Development Review Comments

STP2024-00465

12501 Ardennes Ave.

SITE PLAN

EXISTING CONDITION PLAN
SITE PLAN
TWINBROOK PLACE
12501 ARDENNES AVE
LOT 5, BLOCK E
CITY OF ROCKVILLE 4TH ELECTION DISTRICT, MONTGOMERY COUNTY, MARYLAND

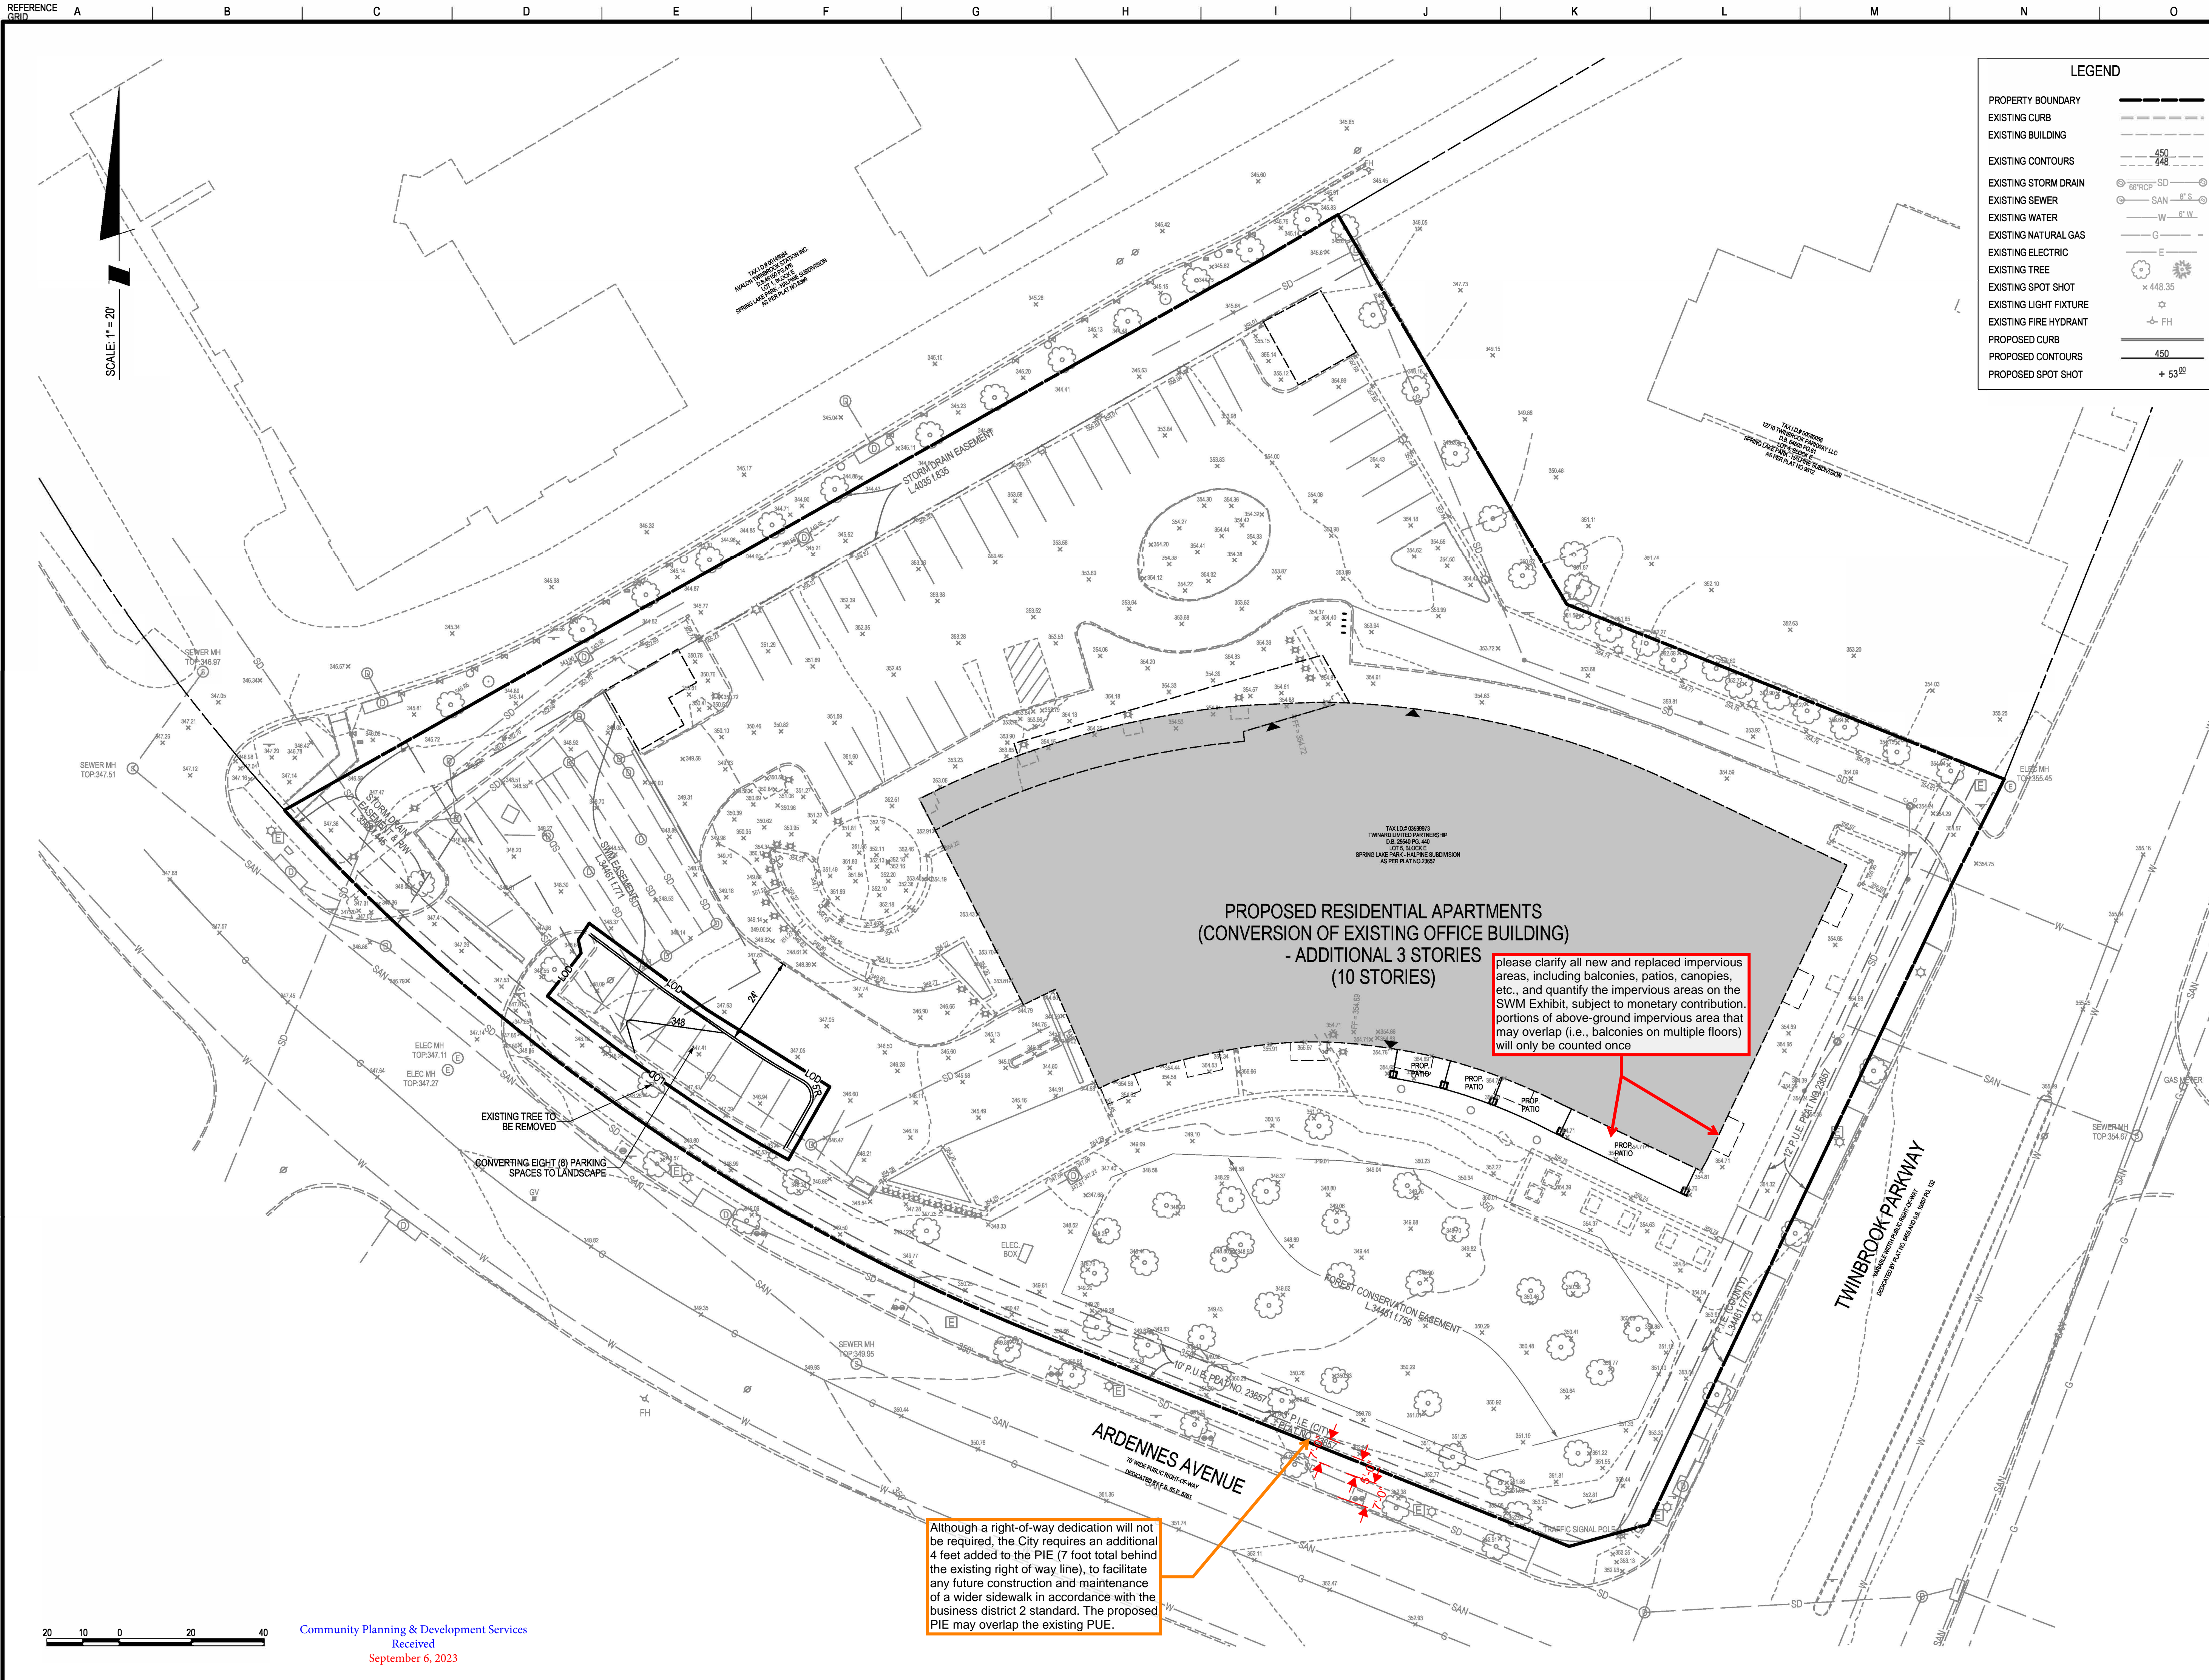
Although a right-of-way dedication will not be required, the City requires an additional 4 feet added to the PIE (7 foot total behind the existing right of way line), to facilitate any future construction and maintenance of a wider sidewalk in accordance with the business district 2 standard. The proposed PIE may overlap the existing PUE.

FIRE PROTECTION SITE PLAN
SITE PLAN
TWINBROOK PLACE
12501 ARDENNES AVE
LOT 5, BLOCK E
CITY OF ROCKVILLE (4TH) ELECTION DISTRICT, MONTGOMERY COUNTY, MARYLAND

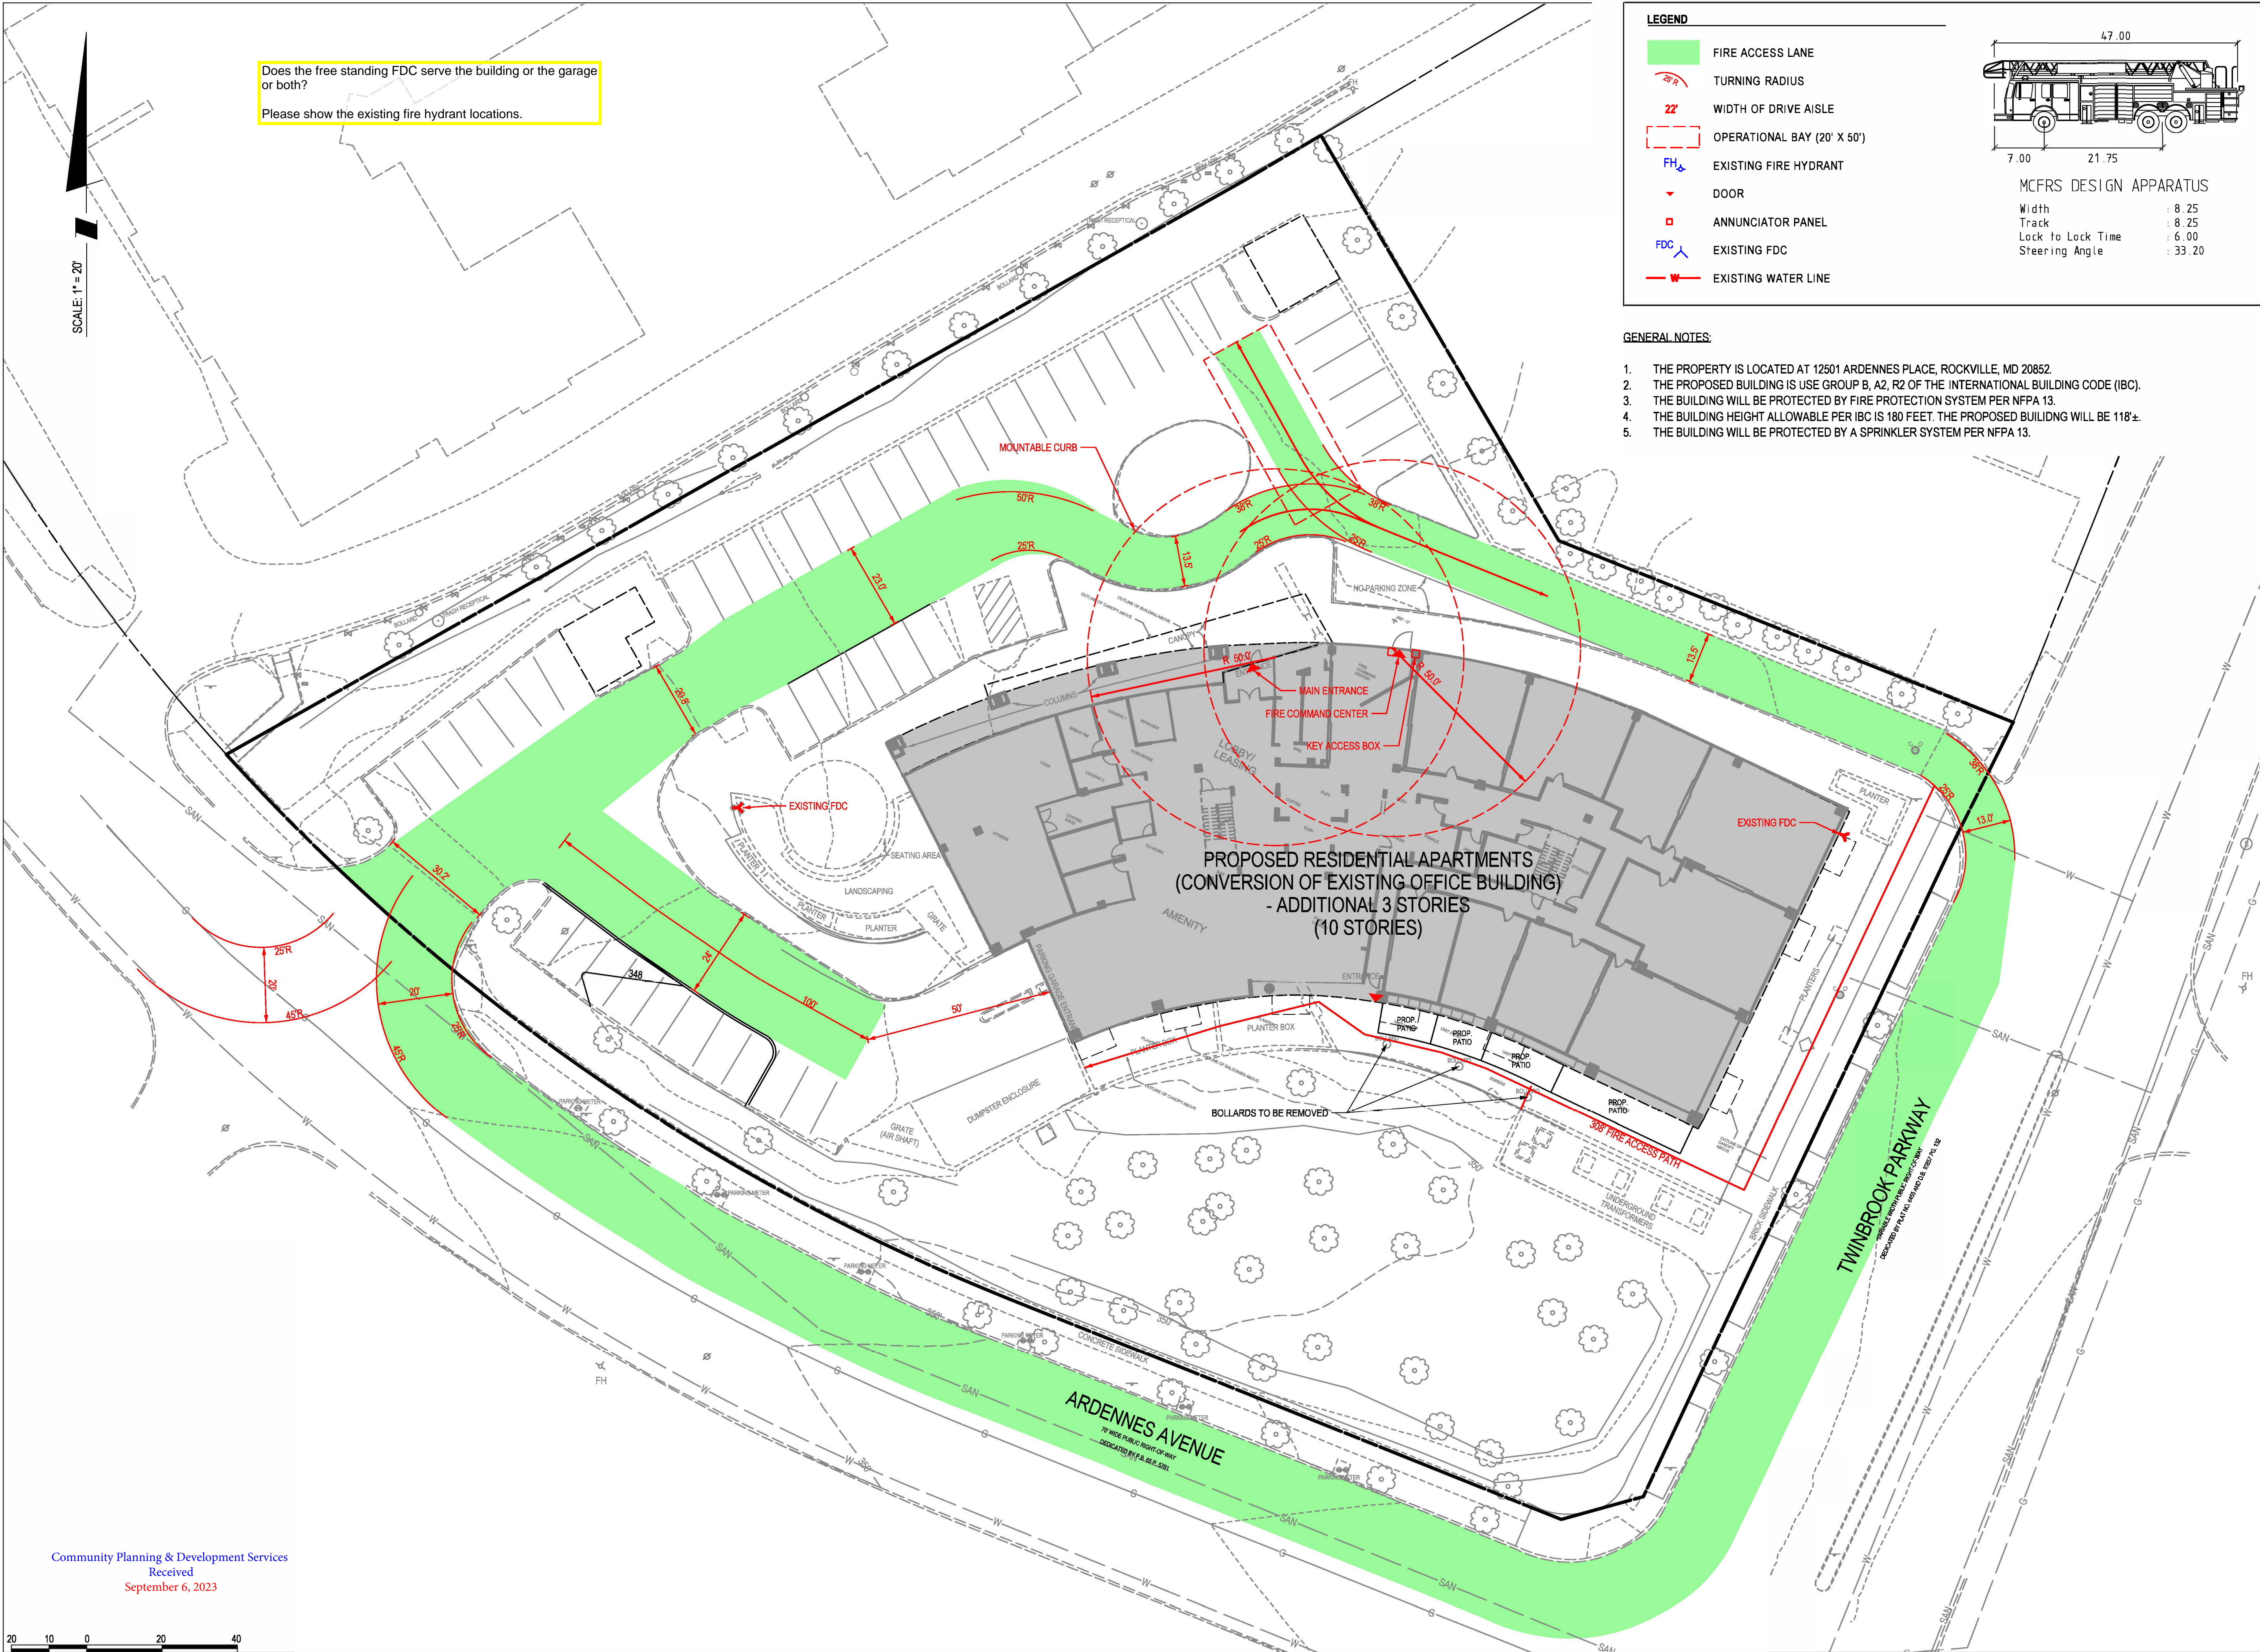
Does the free standing FDC serve the building or the garage or both?
Please show the existing fire hydrant locations.

SHEET
SP-5

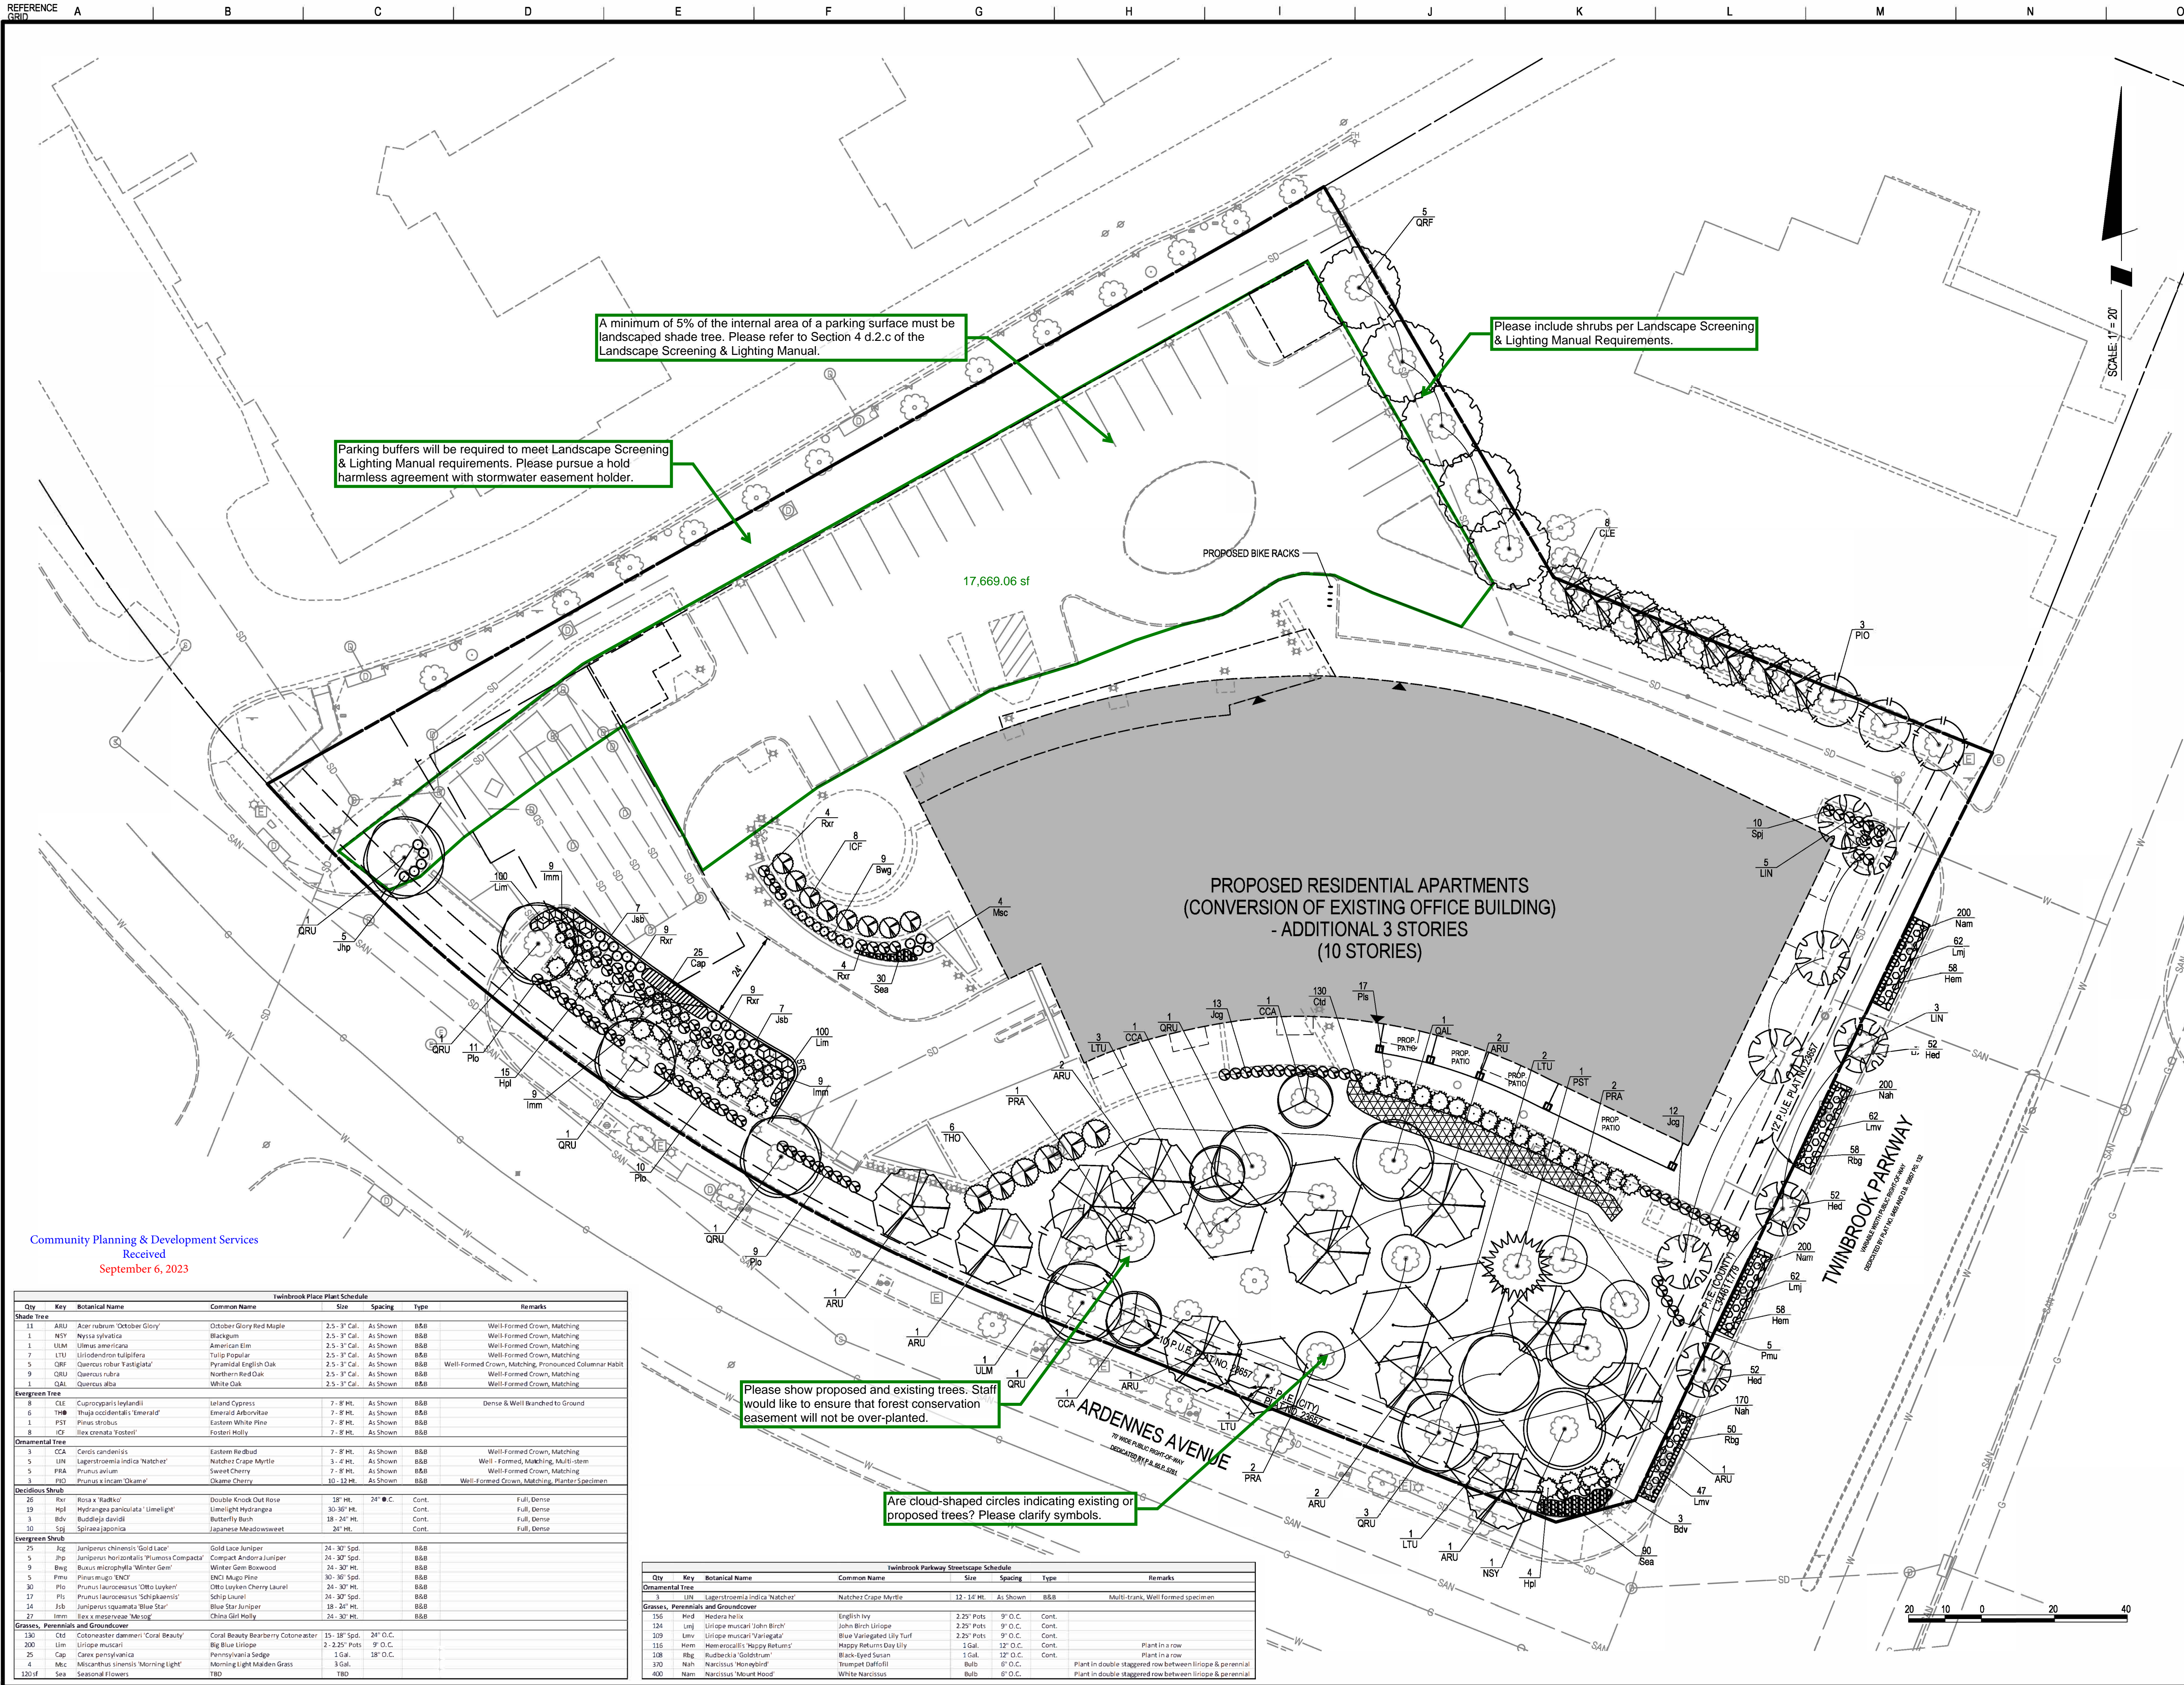
8. Please verify if site plan survey is current.
9. Provide additional information on loading spaces and the proposed zones.
10. Provide additional information on the programming of the Public Use Spaces within the open area, as highlighted on Sheet SP-5.
